**WHITE LAKE TOWNSHIP
INTER-OFFICE MEMORANDUM
COMMUNITY DEVELOPMENT DEPARTMENT**

**SUBJECT: Ginko Self Storage
Amended Final Site Plan**
located on the north side of White Lake Road, west of Old White Lake Road, consisting of 2.14 acres. Currently zoned Light Manufacturing (LM). Identified as vacant parcel 12-01-127-004
Applicant: Ginko Investments, LLC

RE: **Ginko Self Storage -Final Site Plan/Final Engineering Plan Review-4th Review**
~~Stormwater Maintenance Agreement Review-1st Review~~

Revised Final Site Plan Review for Special Land Use for White Lake Charter Township, Michigan

DRAWING TITLE
UTILITY PROFILES

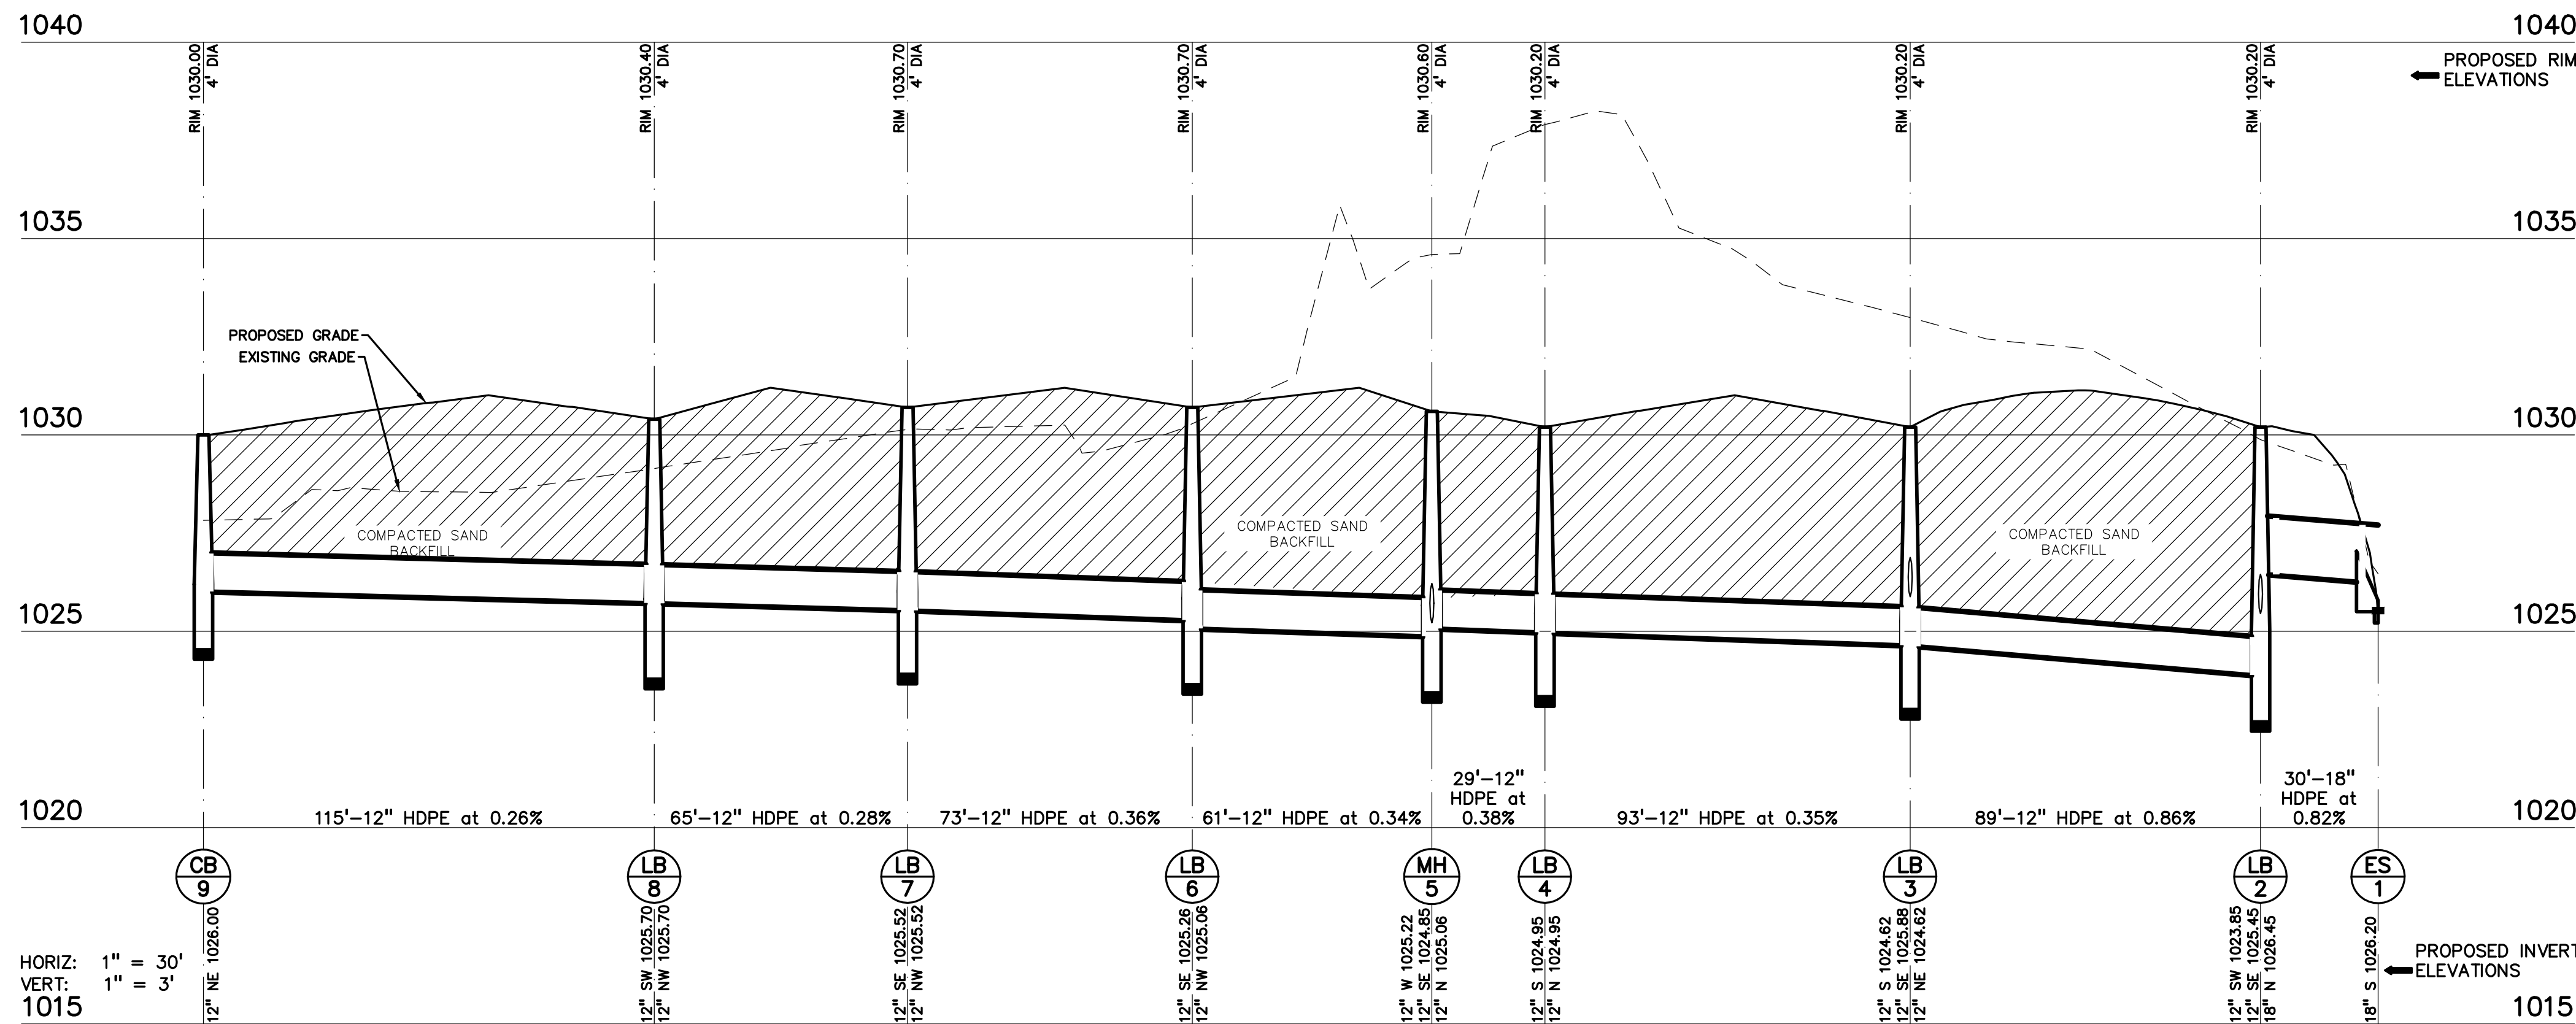
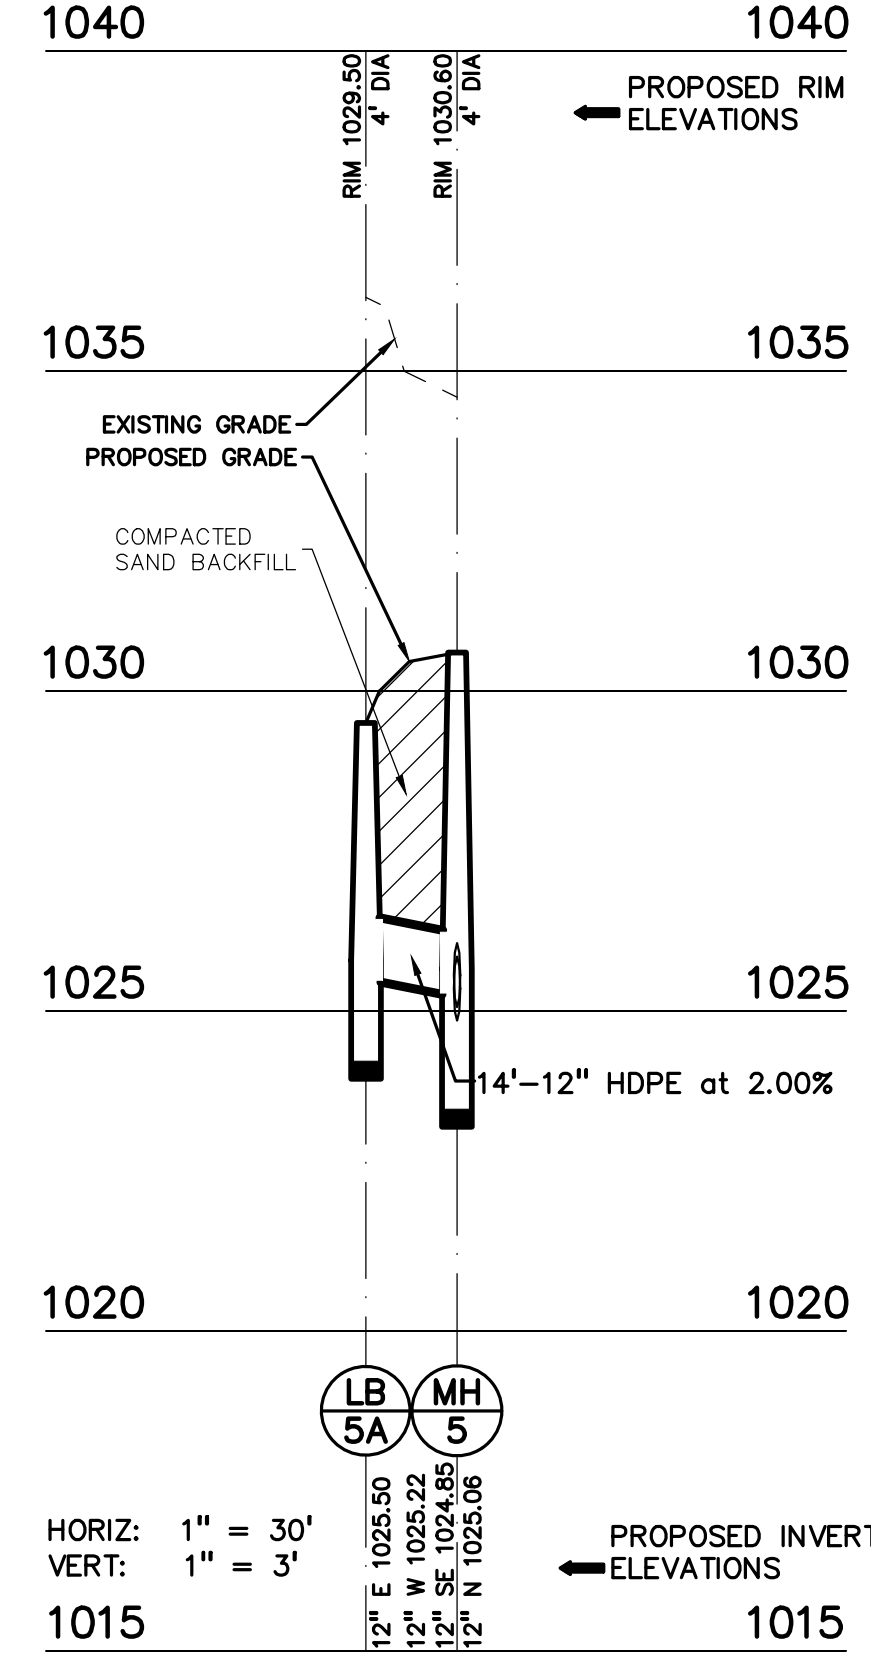
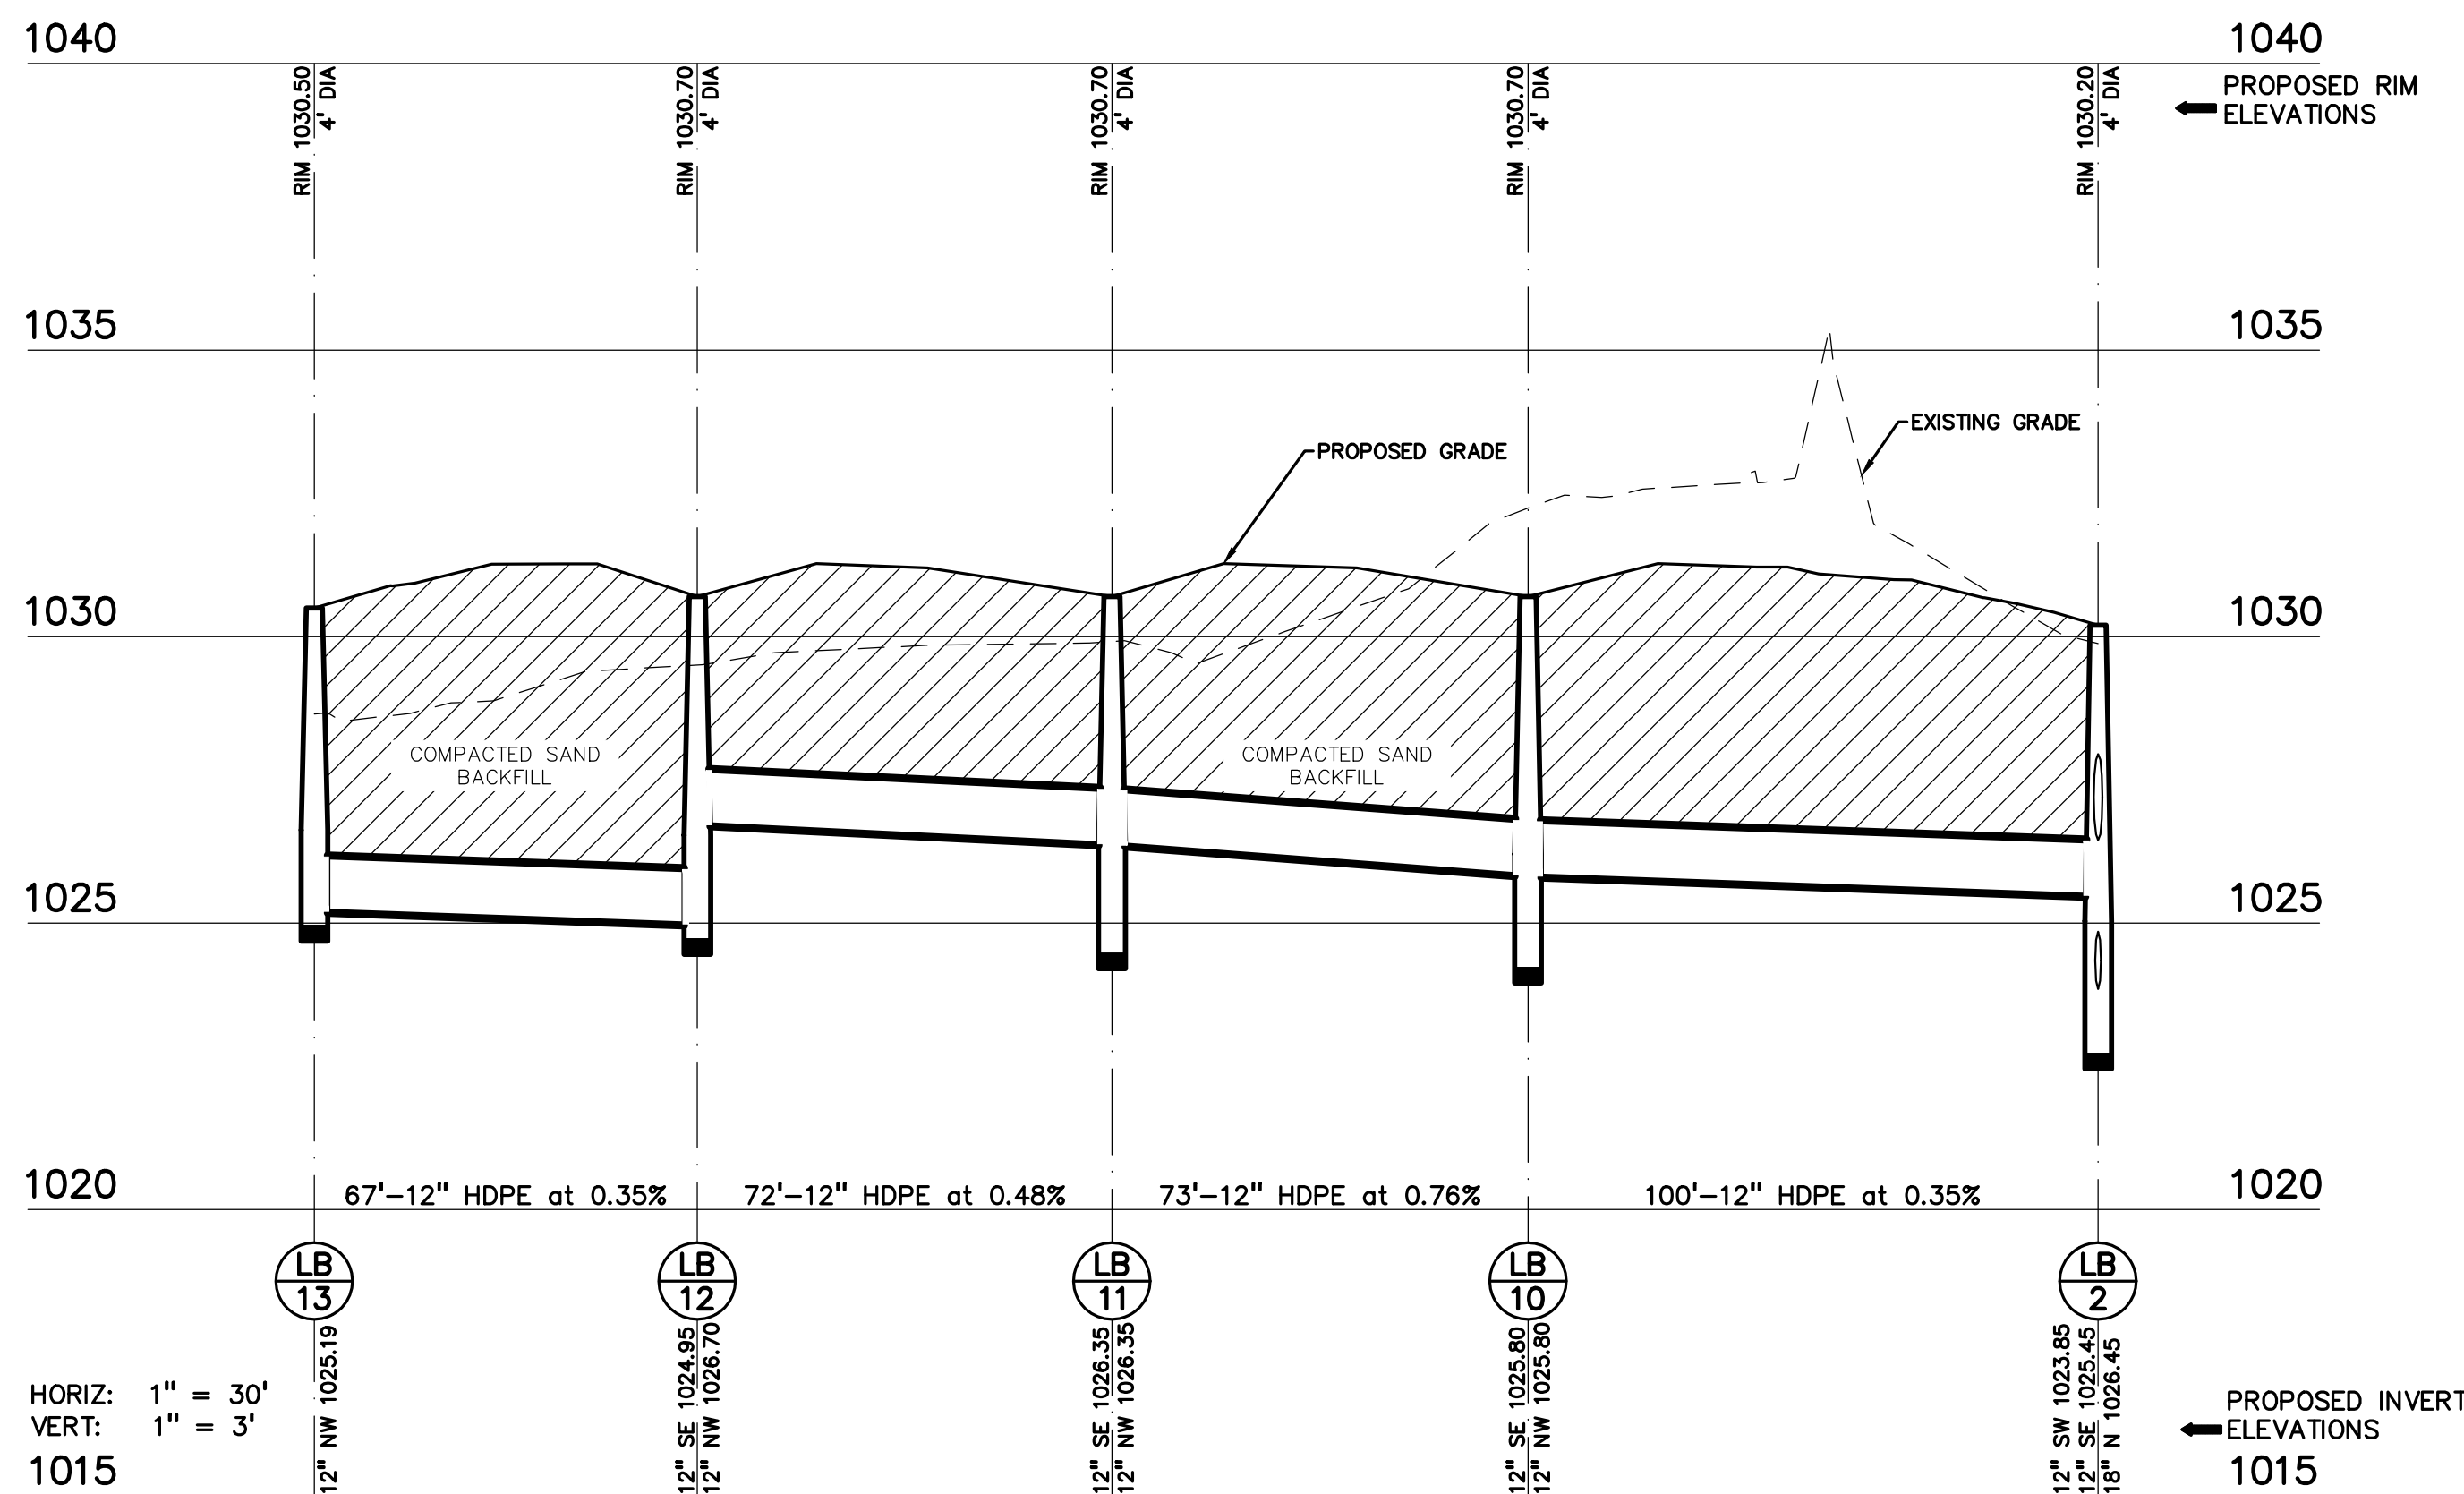
3. Sheet C-7.0- It appears that profiles were not updated based on revised storm sewer structure rim and invert elevations. We have attached a red lined copy of this sheet.
